HORSHAM DISTRICT COUNCIL CONSULTATION

TO:	Horsham District Council – Planning Dept
LOCATION:	Mowbray Development Site, Employment Land
DESCRIPTION:	Construction of Primary Road from the Left-In, Left-Out junction with the A264 (constructed pursuant to Outline Planning Permission DC/16/1677) to Bush Lane (Bridleway 1585), footpaths and cycleways, foul and surface water drainage including a SUDS basin and foul pumping station, landscaping, substations and associated infrastructure.
REFERENCE:	DC/25/1543
RECOMMENDATION:	Objection-No objection / more information
SUMMARY OF COMMENTS & RECOMMENDATION:	
Many of the outstanding concerns have been resolved. Some remain, largely requesting amendments and inclusions within any forthcoming HMMP. It is at the case officer's discretion whether the RCA methodology and details are sought prior to grant of planning permission. The updated metric demonstrates that the development will have a 15.13% net gain (+1.99 units) in area habitats, a 142.70% net gain (+6.85 units) in hedgerows, and a -1.19% net loss (-0.06 units) in watercourses. The change results in more other neutral grassland in moderate condition being proposed, and improved classificat

^BNG Report Phase 1 Map (2025).

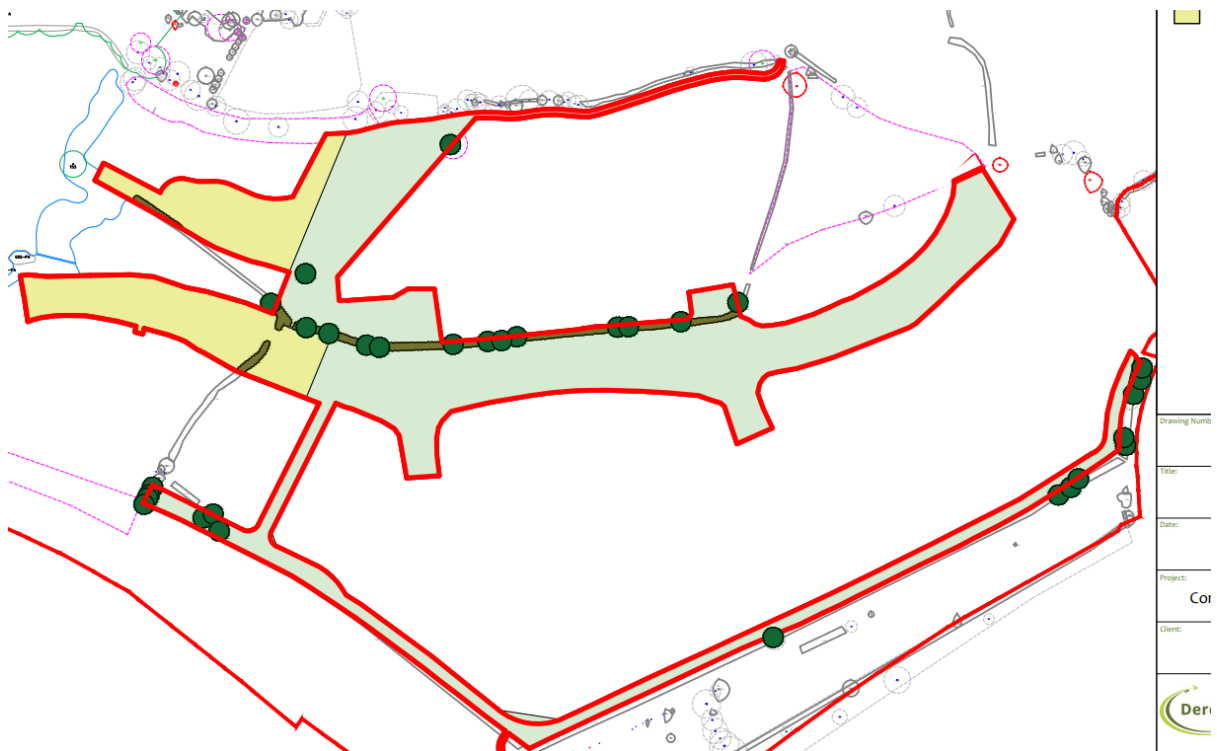
130sqm of woodland has been entered within the metric, although it cannot be clearly ascertained from the Phase 1 Map whereabouts this is located on the site. Please can this be added.

The ecologist has confirmed in the Further Ecology Information note that the woodland is '*contiguous with the Channells Brook along the north of the site*'. However, this does not appear to be mapped, and it is my understanding that this parcel of woodland is outside the red line boundary and not subject to any impacts. On further investigation, I believe the woodland included in the metric are the sections to be removed to facilitate drainage and earth works in the west of the site.

Please can these parcels be added to the Phase 1 Map for purposes of including in the HMMP. In addition, please can the watercourses subject to RCA also be added.

This has been provided in the BNG report – with thanks. Please include this and post-development map in LEMP/HMMP when finalising for legal agreement.
